From: SurdykaArchitect@bellnet.ca
To: [North York Community Council](#)
Cc: [Ben DiRaimo](#); "[Rick Blacker](#)"; "[Benjamin Leung](#)"
Subject: 2021.NY27.2 Zoning By-law Amendment Application - 151 Billy Bishop Way
Date: October 12, 2021 10:07:11 PM
Attachments: [communicationfile-137407.pdf](#)
[15-02 A1.0 Site Plan.pdf](#)
[200665 \(151 Billy Bishop Way TIA TP Comment Matrix\) - LETTER 1.0.0 - FINAL - 2020-04-01 \(002\).pdf](#)

RE: Review of Transportation Impact Study for 151 Billy Bishop Way, City of Toronto

**RE: 151 BILLY BISHOP WAY – NEW CAR DEALERSHIP,
TRANSPORTATION IMPACT STUDY – UPDATE
TRANSPORTATION PLANNING COMMENT RESPONSE**

Figure reproduced from: 151 Billy Bishop Way, New Car Dealership, Transportation Impact Study – Update, dated February 2021, Paradigm Transportation Solutions Limited, Figure 3.1 Site Concept Plan

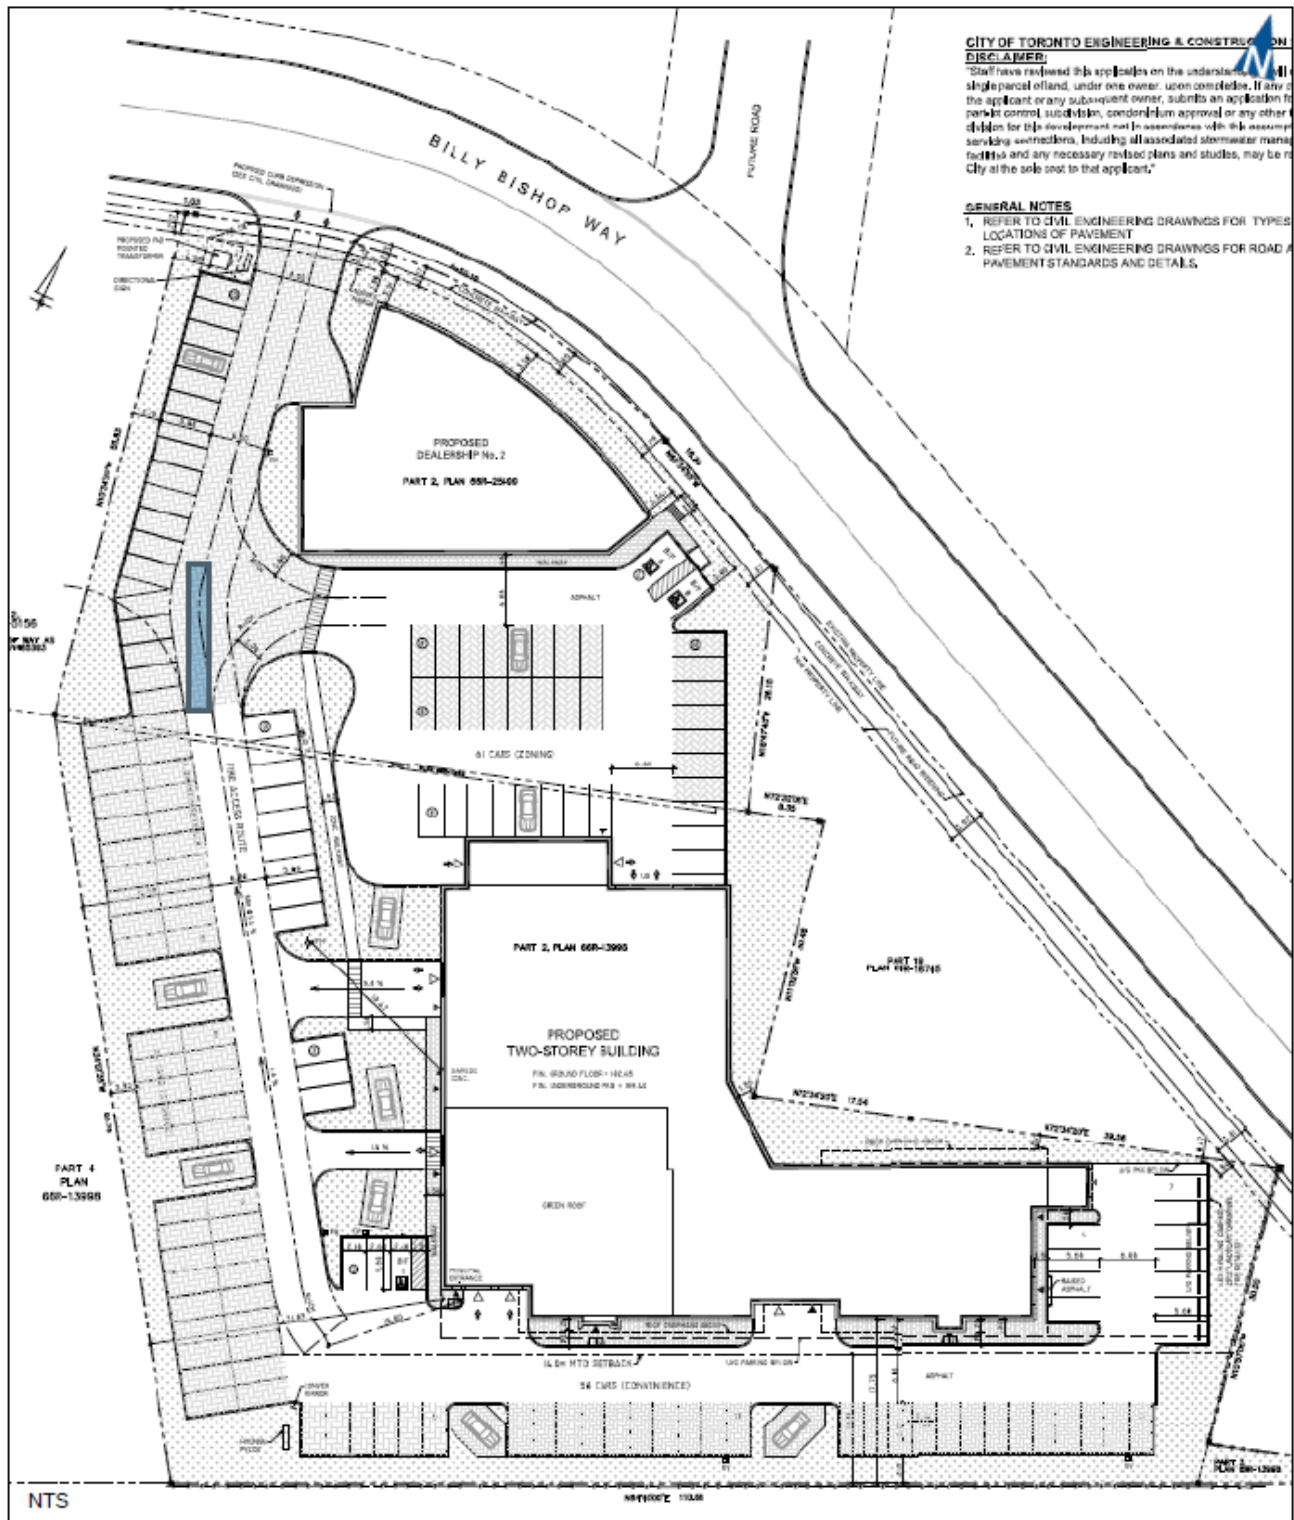
The development concept plan documented in the Paradigm report includes two new car dealerships with vehicle access provided by a single full-movement driveway connection to Billy Bishop Way. Build-out and occupancy of the site is anticipated to occur by 2024. A copy of the concept site plan is attached to this letter for reference.

Based on a preliminary review of the driveway location, which appears to be in approximately the same location as the existing driveway as shown on the sketch below, the available storage length is 90m (measured from the stop bar on the westbound approach at the Dufferin Street/Billy Bishop Way intersection to the west curb at the existing driveway) both the 95th and 50th percentile queue lengths will block the site driveway. The operational issues related to this are further discussed below as they relate to the proposed implementation of left turn lanes at the site driveway.

- At the site access driveway, a westbound left-turn lane is warranted with 25m storage length. At the Dufferin-Wilson Study North-South Greenway Street (future road), an eastbound left-turn lane is warranted with 25m storage length. It is recommended that the alignment of the Dufferin-Wilson Study North-South Greenway Street is shifted to align with the site driveway to form a conventional four-legged intersection and to allow for the development of the left turn lanes on Billy Bishop Way. The Paradigm report states that the westbound left-turn lane can be accommodated through a lane restriping of the existing two-way left-turn lane.

The City of Toronto should confirm if the realignment of the future road is feasible as recommended, or if an alternate site driveway alignment should be considered. The existing left turn lane on the westbound approach at the Dufferin Street/Billy Bishop Way intersection extends to the site driveway. The existing two-way left-turn lane starts east of the site driveway. This configuration would not accommodate an eastbound left turn lane as proposed and would require the proposed westbound left turn lane to be “nested” in the existing westbound left turn lane. A functional design should be provided to demonstrate how the proposed implementation of left turn lanes at the site driveway can be accommodated within the existing right-of-way and to confirm geometry. Due to the curvature of Billy Bishop Way in this section, a review of driver sight lines should be completed for the proposed site driveway based on the posted speed of 40km/hr. Consideration should be given to restricting the driveway to right-in/right-out/left-in movements under the existing road configuration and right-in/right-out only when the future road is constructed.

DRIVEWAY SIGHT DISTANCE REVIEW

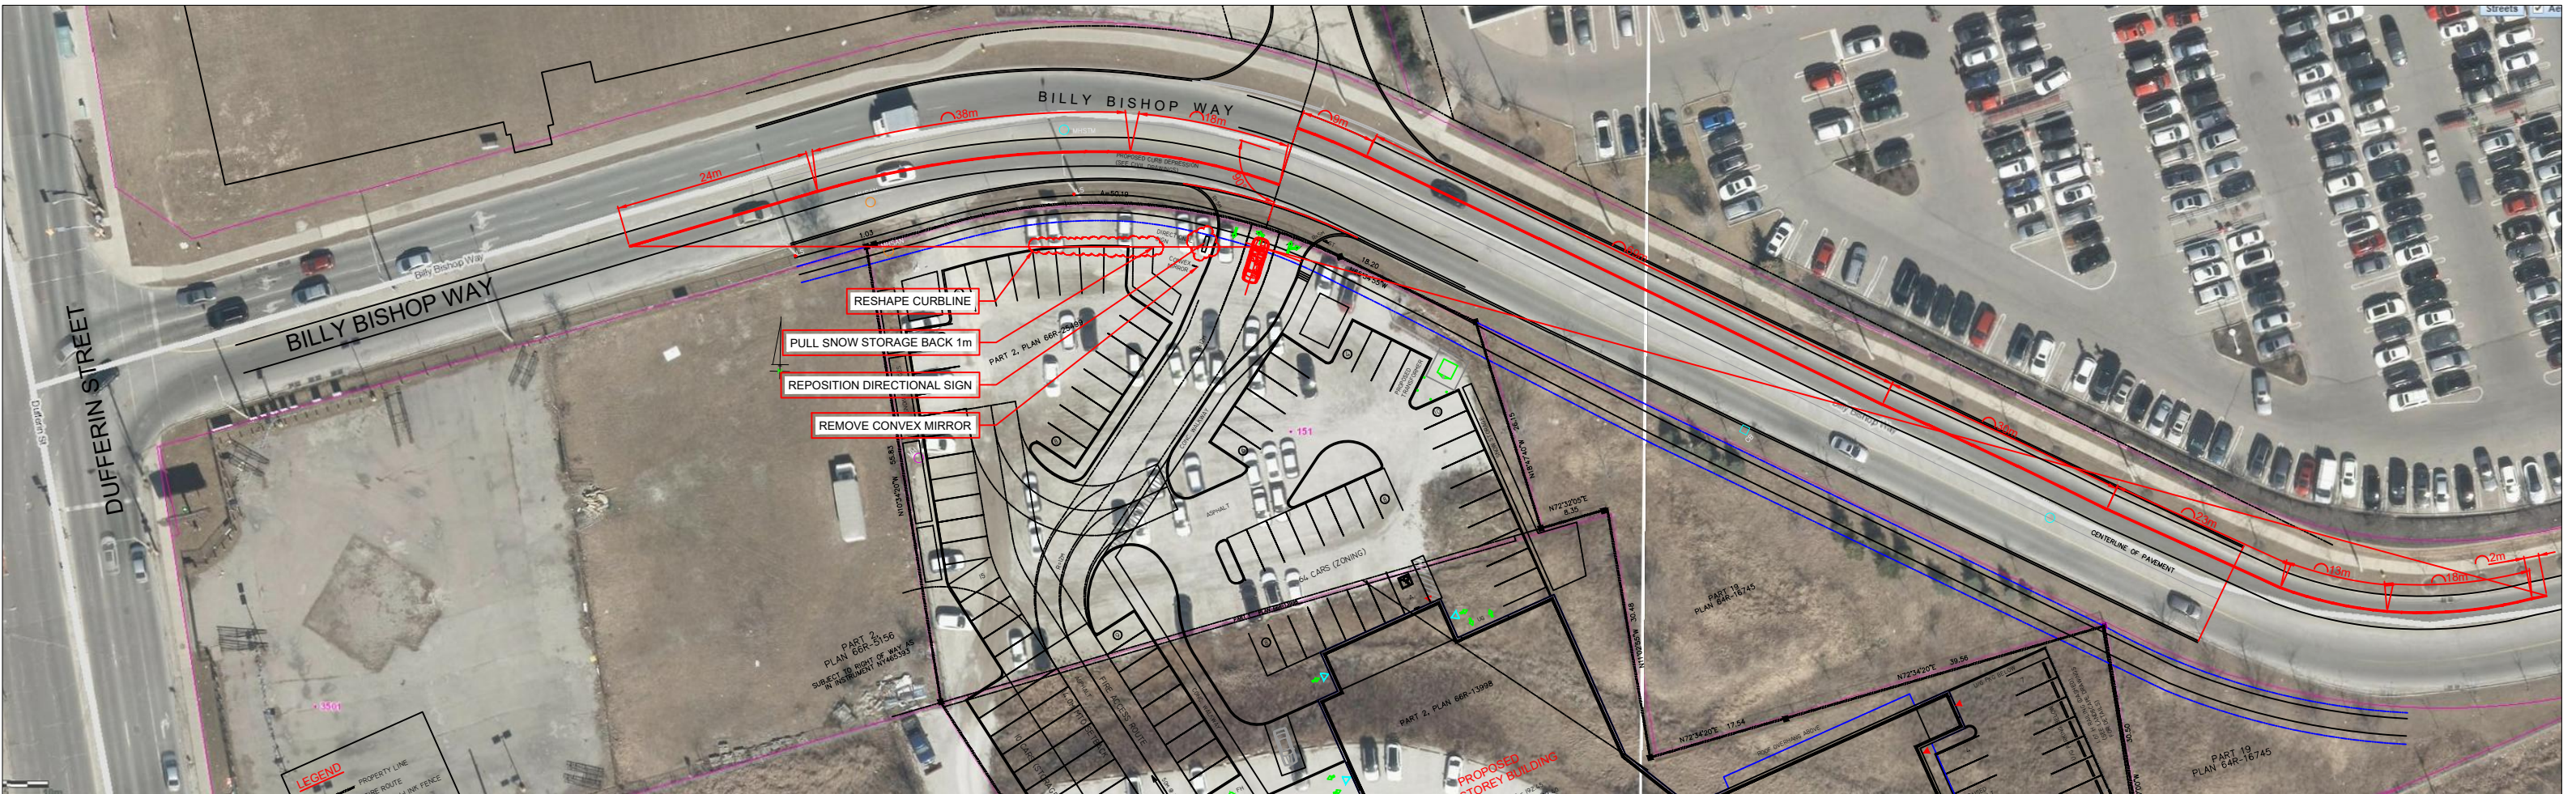
<p>provide back-to-back left-turn lanes. To accommodate turning vehicles, it would be preferred if the driveways were aligned to form a conventional four-legged intersection. The alignment of the driveways would allow for the development of the warranted auxiliary lanes."</p>	
<p>City is in agreement with the recommended preferred design to align the site driveway to the Dufferin-Wilson North-South Greenway Street to minimize the conflicting movements. Further comments to be provided by Transportation Services staff.</p>	<p>The driveway intersects Billy Bishop Way at 90 degrees and is aligned with Dufferin-Wilson North-South Greenway Street.</p> <p><u>Sight Distance</u></p> <p>Sight distance to the west is limited to approximately 80 m when measured within the ROW. Sight distance to the east is limited to approximately 162 m when measured within the ROW.</p> <p>Objects on the site plan impact driver sightlines to the west (sign, snow storage and parking). It's recommended these items be removed/repositioned. There is also a rogue convex mirror that can be removed. Architect to update site plan.</p> <p>Table A summarizes the TAC Guide sight distances for design speeds ranging from 40km/h to 60 km/h (advisory speed for curve to 10 km/h over posted speed limit). Highlighted cells indicate available sight distance is greater than or equal to the TAC Guide measurement. Sight distance diagram is attached.</p> <p>Minimum stopping is available in both directions. Vehicles traveling eastbound from Dufferin Street would likely be accelerating after turning onto Billy Bishop Way and may not be traveling at or near the posted speed limit through the curve. All sight distances are satisfied for a 40 km/h design speed.</p>

TABLE A: SIGHT DISTANCE SUMMARY

Sight Distance	Design Speed	TAC Guide Distance (m)	Scaled Distance (m)	Satisfactory
Minimum Stopping Sight ¹ Eastbound	40 km/h	50	80	Yes
	50 km/h	65	80	Yes
	60 km/h	85	80	No
Minimum Stopping Sight ¹ Westbound	40 km/h	50	162	Yes
	50 km/h	65	162	Yes
	60 km/h	85	162	Yes
Left-Turn from Stop ²	40 km/h	85	162	Yes
	50 km/h	105	162	Yes
	60 km/h	130	162	Yes
Right-Turn from Stop ³	40 km/h	75	80	Yes
	50 km/h	95	80	No
	60 km/h	110	80	No

AutoTURN CITY OF TORONTO AERIAL FIRE TRUCK

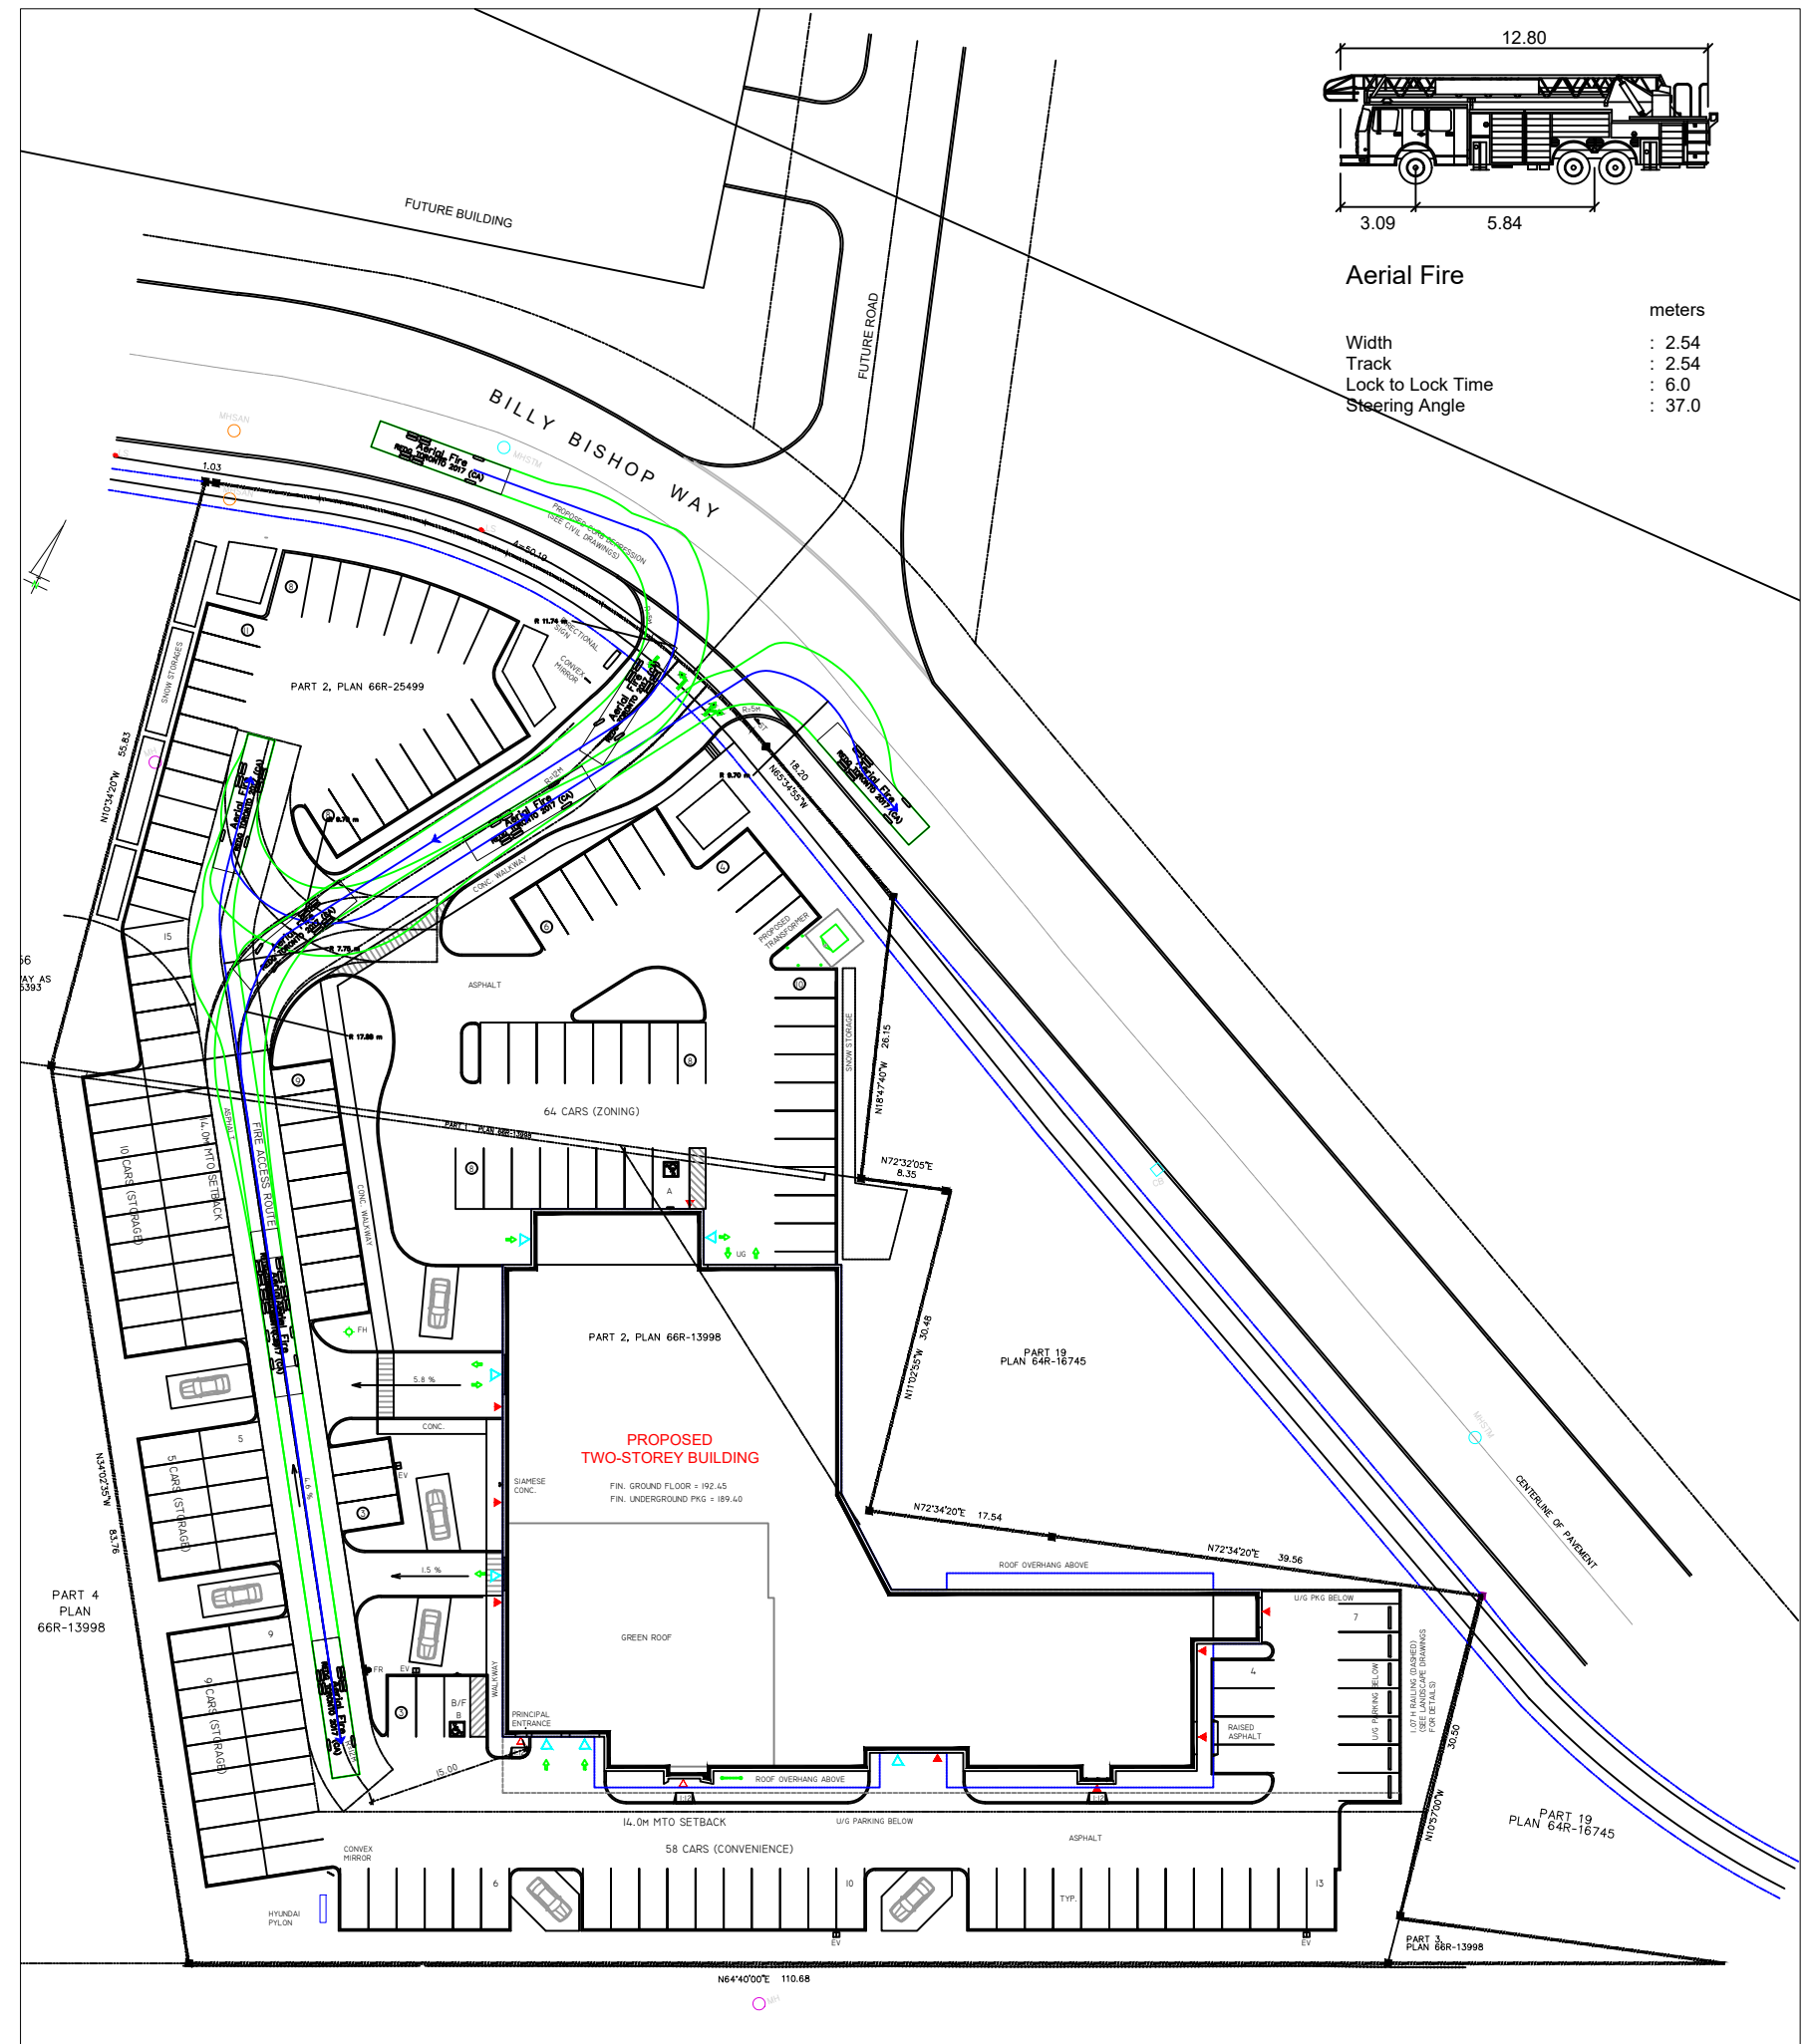
AutoTURN – Fire Truck

No conflicts are identified. The vehicle can turn around on site within the designated fire route. AutoTURN plots are attached.

SITE PLAN

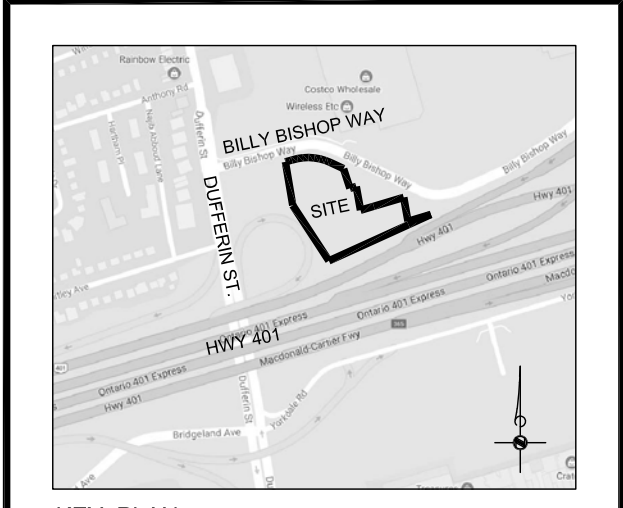
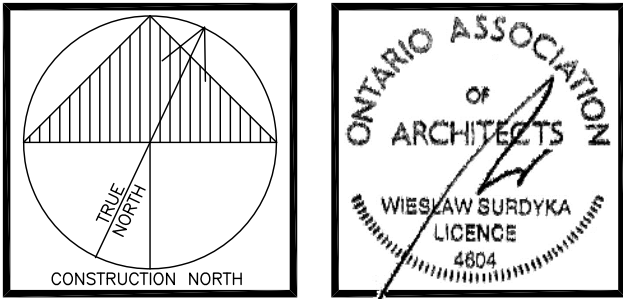
Comment	Response/Action
City of Toronto Comments dated 12 March 2021	
<p>Street Connection and Design: Site Driveway Intersection at Billy Bishop Way</p> <p>The Transportation Impact Study (TIS) Report prepared by Paradigm Transportation Solutions Limited (dated February 2021) stated that "The spacing between the site driveway and the Dufferin-Wilson Study North-South Greenway Street driveway is insufficient to</p>	<p>Site plan updated to align driveway.</p>

The public sidewalks along the frontage of the site on Billy Bishop Way should be upgraded to the City's current design standard to provide a pedestrian clearway that is a minimum of 2.1m wide.

Bicycle Parking:
Although there is no by-law bicycle parking requirement for vehicle dealership use, the applicant should still provide an appropriate amount of long-term and short-term bicycle parking spaces on site (e.g. for the office

<p>Travel Demand Management (TDM) plan:</p> <p>In accordance with the policies in the City's Official Plan, Toronto Green Standard (TGS) – Version 3, Guidelines for the Preparation of Transportation Impact Studies (2013), the applicant shall identify the appropriate travel demand management programs/measures to be implemented on/for the subject site to reduce the single occupancy auto vehicle trips generated by the proposed development. A stronger TDM plan is required for this site, the following is a list of additional TDM measures that are considered appropriate for the subject site:</p>	<p>Architect to update site plan to provide bike repair station</p>

<p>Bike Repair Station - install and maintain an appropriate number of bike repair stations in or near bicycle parking areas on site.</p>	
<p>Carpool Parking Spaces - install and maintain carpool parking spaces for employees and visitors.</p>	<p>Architect to update site plan to identify location of carpool parking spaces for employees.</p>
<p>EV Charging Stations/Spaces and Provision:</p> <p>Underground Parking: <input type="checkbox"/> In accordance with the City's Toronto Green Standard (TGS) – Version 3 – AQ1.3 Electric Vehicle Infrastructure, the applicant shall "design the building to provide 20 per cent of the parking spaces with electric vehicle supply equipment (EVSE). The remaining parking spaces must be designed to permit future EVSE installation."</p>	<p>Architect to review with applicant and update site plan accordingly.</p>
<p>Please identify on the Site Plan/Floor Plans the locations of all the proposed EVSE parking spaces, and confirm that the remaining parking spaces are designed to permit future EVSE installation.</p>	<p>Architect to review with applicant and update site plan accordingly.</p>

<p>o Outdoor Parking:</p> <p>Although outdoor parking lots are excluded from the EVSE requirements in the City's Toronto Green Standard (TGS), it is still a recommendation to the applicant to consider installation of some outdoor EVSE parking spaces on site, or design the outdoor parking spaces to permit future EVSE installation.</p>	<p>Architect to review with applicant and update site plan accordingly.</p>
<p>City of Toronto Comments dated 29 March 2021</p>	
<p>-Provide turn around area for parking spaces located at the</p>	<p>Architect to remove parking space in underground to provide turn around area.</p>

south west and northwest corner of the underground parking garage; and	
-Please provide convex mirrors at the ends of drive aisles and in all corners/turns within the underground parking garage.	Architect to provide convex mirrors at the ends of drive aisles and in all corners/turns within the underground parking garage.

Architect to update site plan to include public sidewalks along the Billy Bishop Way frontage.

Architect to provide bicycle parking in accordance with the requirements in the Zoning By-law 569-2013

<p>component of the proposed development) as per the recommendation in the TIS report.</p>	<p>a retail store; and (B) in Bicycle Zone 2 is 3 plus 0.25 bicycle parking spaces for each 100 square metres of interior floor area used for a retail store.</p> <p>Long-Term Bicycle Parking</p> <p>the minimum number of long-term bicycle parking spaces to be provided: (A) in Bicycle Zone 1 is 0.2 for each 100 square metres of interior floor area used for a retail store; and (B) in Bicycle Zone 2 is 0.13 for each 100 square metres of interior floor area used for a retail store.</p>
<p>All the proposed bicycle parking spaces should be identified on the Site Plan/Floor Plans.</p>	<p>Architect to update site plan to illustrate short-term and long-term bicycle parking.</p>
<p>All the bicycle parking spaces should be provided and designed in accordance with the requirements in the Zoning By-law 569-2013, Toronto Green Standard (TGS) – Version 3 and Guidelines for the Design and Management of Bicycle Parking Facilities.</p>	<p>Architect to update site plan to illustrate short-term and long-term bicycle parking.</p>

REQUIRED: By Law 569-2013 for Retail Store Category - Bicycle Zoning 2
Short-term: 3 + (0.25 spaces/100sm x 838 sm (retail)) = 5.1 spaces
Long-term: 0.13 spaces/100sm x 838 sm (retail) = 1.1 spaces

Short-term:	6 spaces (On Surface)
Long-term:	2 spaces (Underground)
